APPROVED DRAWINGS HAVE BEEN RED LINED INDICATING A CHANGE TO MEET THE OBC. PLEASE REVIEW ALL PAGES TO ENSURE YOU ARE PROPERLY INFORMED OF CHANGES.

These Plans have been examined for Compliance with the Ontario Building Code requirements. A Building Permit has been Issued, subject to any changes noted, under the condition that the building will be constructed in accordance with the code.

Legacy

client
Tice River Homes
project
Legacy

REAR ELEVATION 'A', 'B', 'C' & 'D'

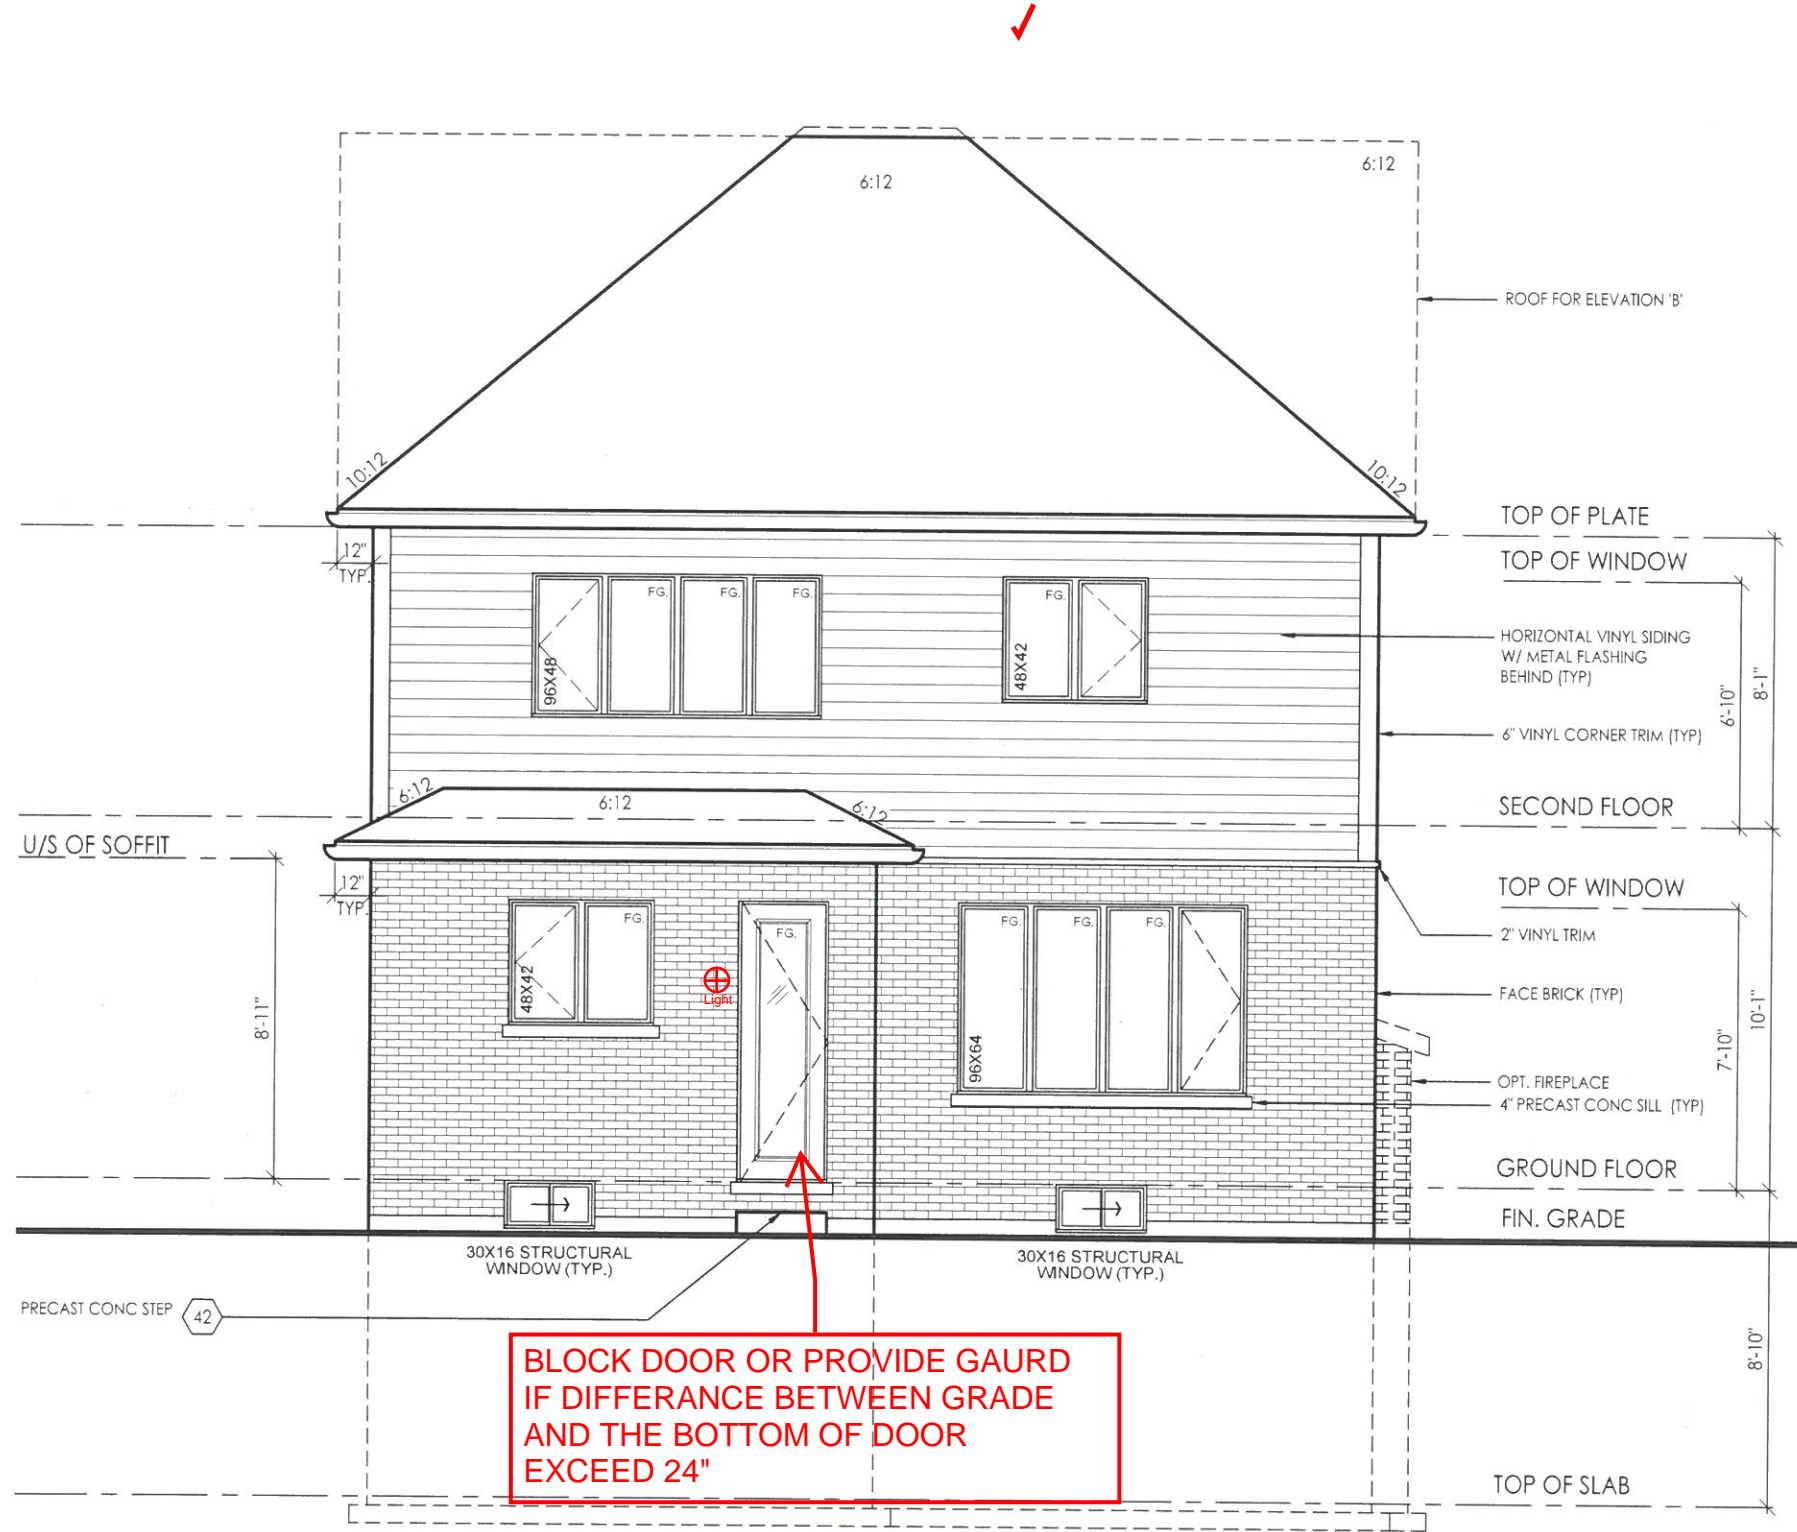
BLOCK DOOR OR PROVIDE GAURD IF DIFFERENCE BETWEEN GRADE AND THE BOTTOM OF DOOR EXCEED 24"
